Re: Permit: Woodland Cove Apartments Comprehensive Permit  
Applicant: Dakota Partners, Inc.  
Property: 3102 Cranberry Highway  
Request: Notice of Project Change/Insubstantial Modification Request

Dakota now requests a further revision to the Phasing Plan and the Endorsed Plan as shown on the plan sheets enclosed herewith that are entitled and dated as follows:

**WOODLAND COVE**

PLAN OF LAND

SV-1.0

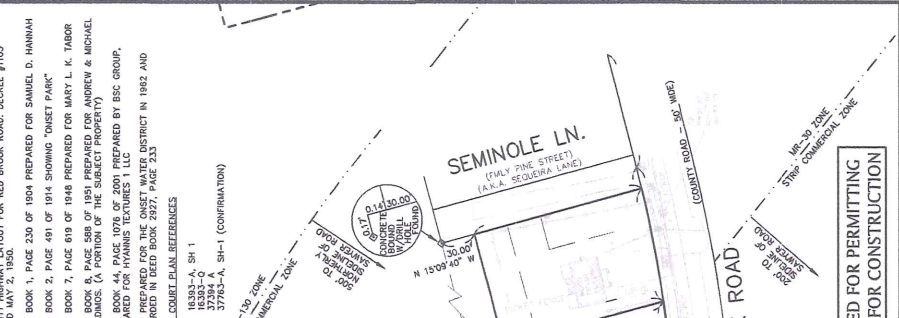
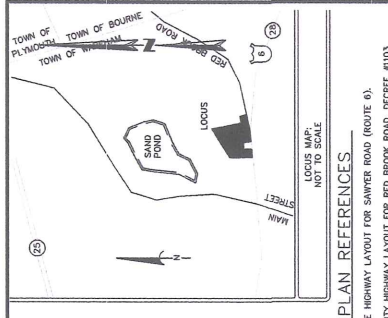
Dakota requests that the Board vote to determine, under 760 CMR 56.05(11), that the revisions set forth in the above materials are insubstantial in nature and that the Board then endorse the revised Plan of Land Sheet in the signature block provided.

It was MOVED and SECONDED and then VOTED by the Board to determine that the December 3, 2020 Notice of Project Change request (a copy of which is attached hereto, together with the accompanying plan sheets) for the Woodland Cove Apartments Comprehensive Permit Project proposes only insubstantial changes within the meaning of 760 CMR 56.05(11) and, further, to endorse the Plan Sheet entitled "Plan of Land, Sheet SV-1.0," dated January 12, 2018, as revised through November 24, 2020.

**C-5.0**

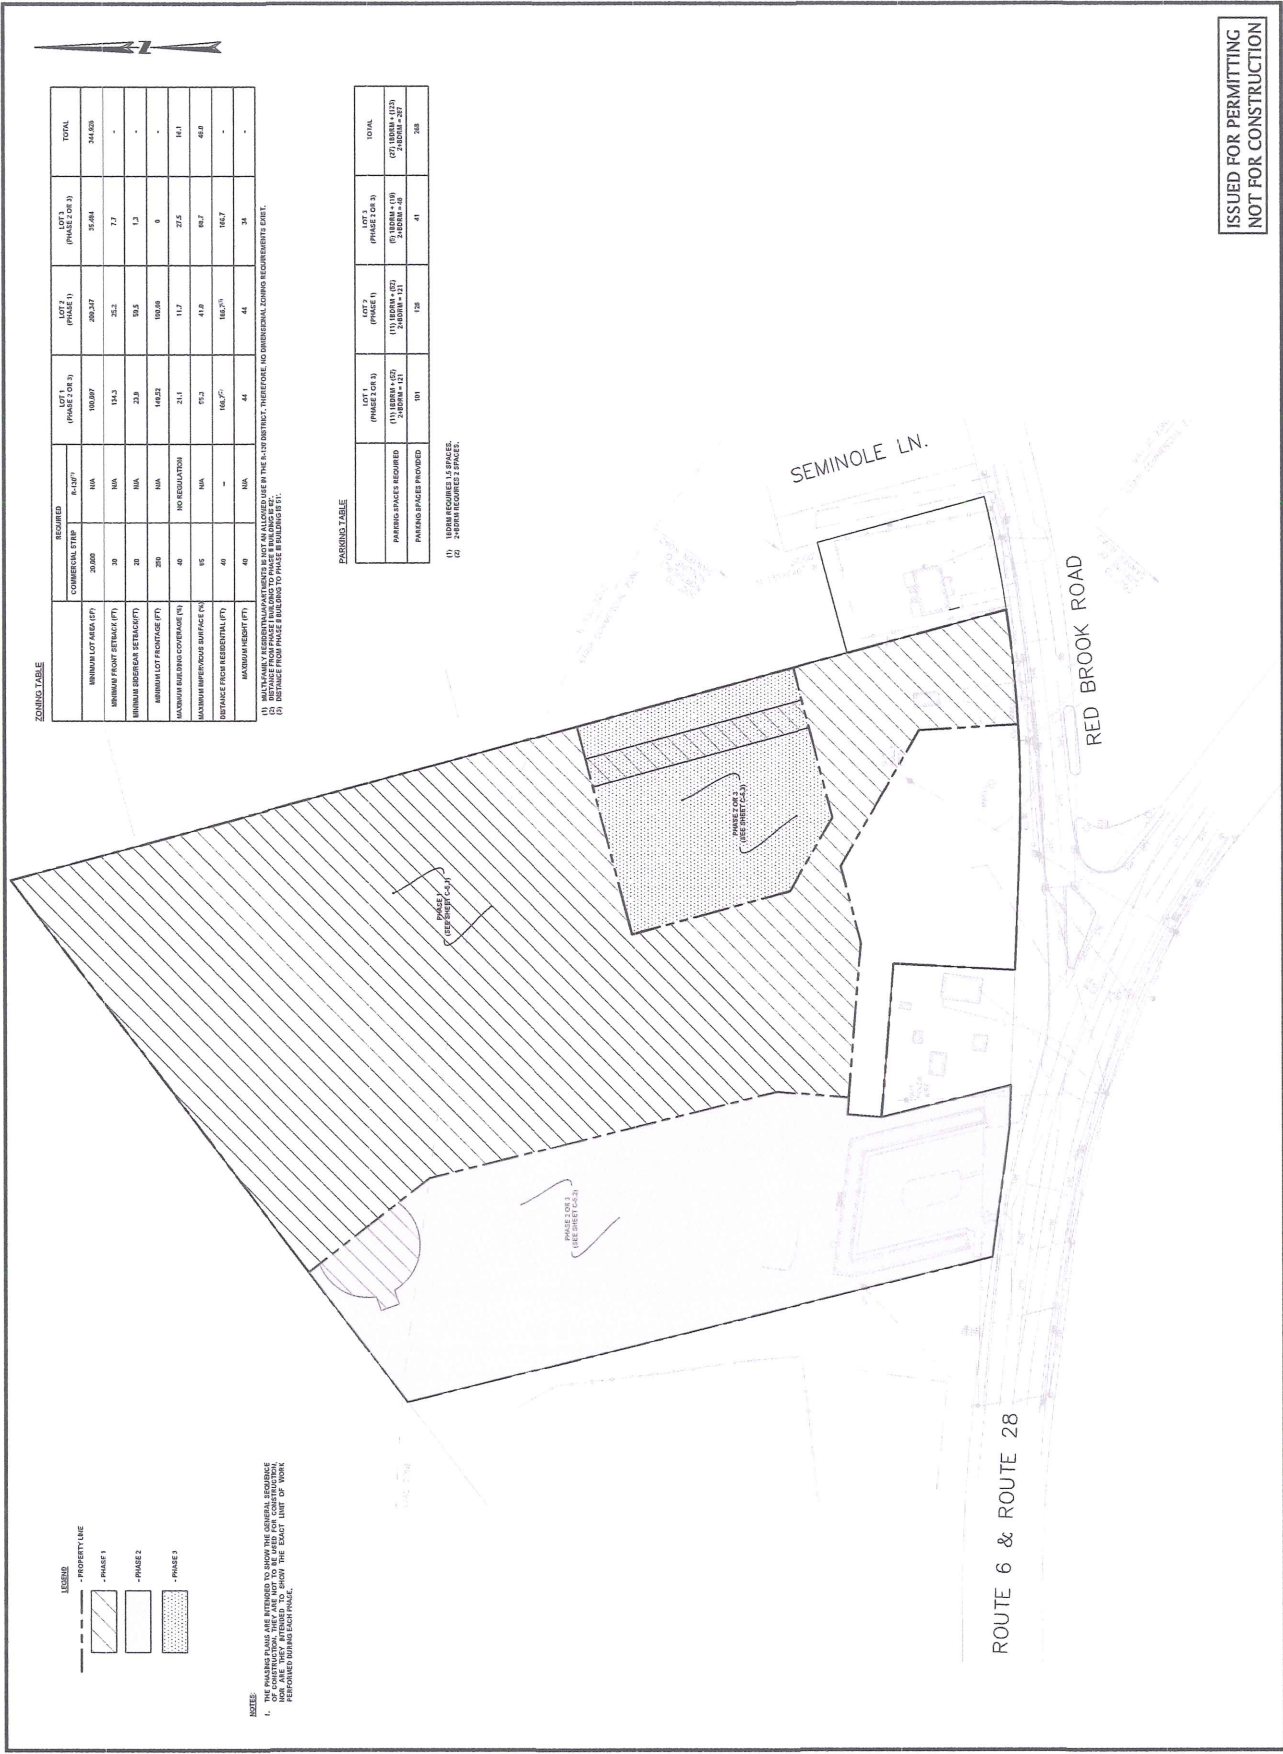
The enclosed materials provide for the following phasing alterations and would reconfigure the parcels as follows:

- i. Buildings E & F become Phase I (currently Phase II)
- ii. Buildings A & B become Phase II or III (currently Phase I)
- iii. Building D becomes Phase II or III (currently Phase II)
- iv. Community Building remains in Phase I as currently approved
- v. Motel to be demolished after completion of affordable units in Phase 1.
- vi. The parcel configurations are altered to conform to the new Phases.

C-5.1

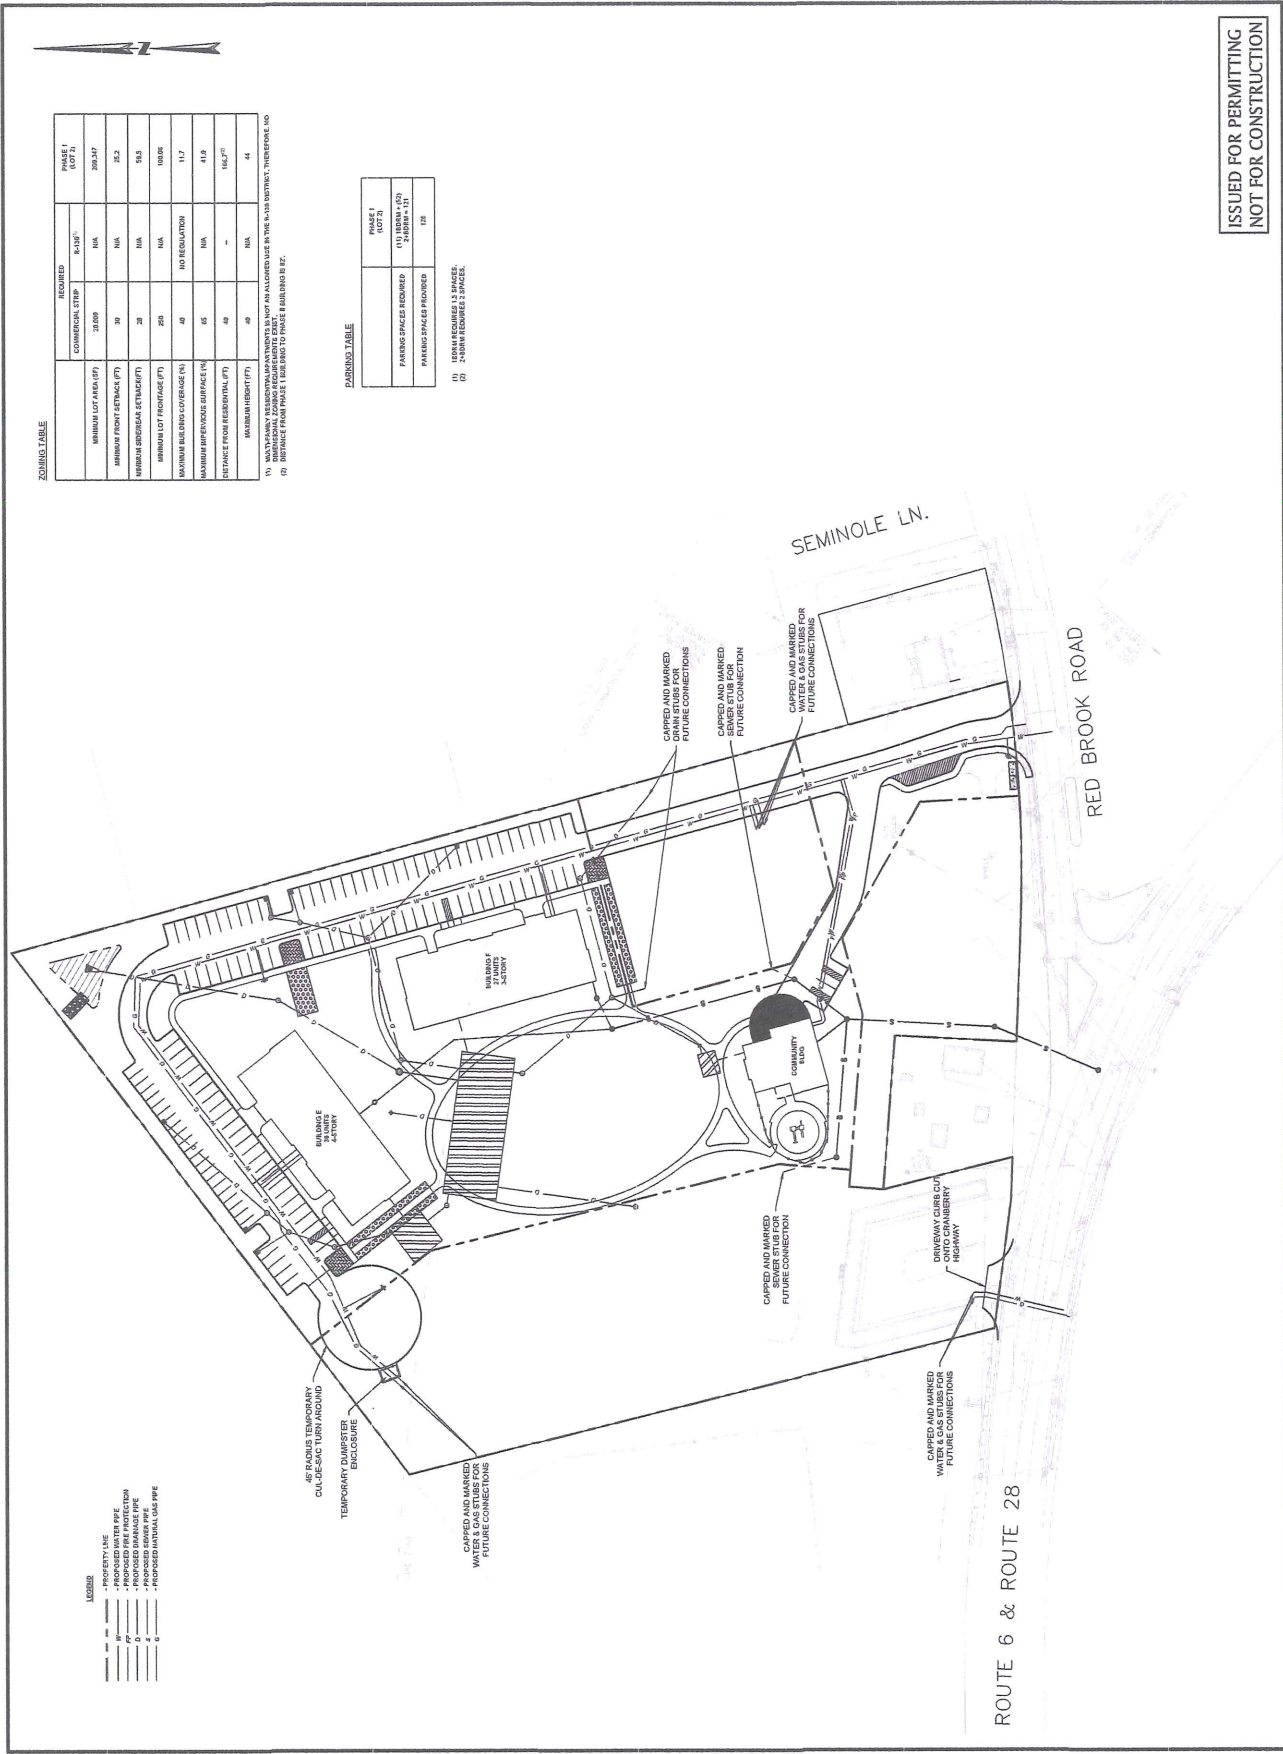
- i. Buildings E & F will provide same unit count and same affordable unit count/breakdown as Buildings A & B.
- ii. Phase I will now only include completion of Red Brook Road driveway. A temporary cul-de-sac will be built northwest of Building E to allow emergency vehicle turn around.
- iii. The driveway entrance on Cranberry Highway will be constructed at the conclusion of Phase I (after Motel demolition), but will not be used until construction of Buildings A & B.

- iv. To allow the Motel to remain for start of Phase I, sewer service connection will be relocated to a more central portion of site and run through Lot 4 to Cranberry Highway.
- v. Water, gas, electric, and telecom services will all remain the same. Water & gas service stubs will be built at the Cranberry Highway driveway location into the property during Phase I.
- vi. Phases II and III will be interchangeable.
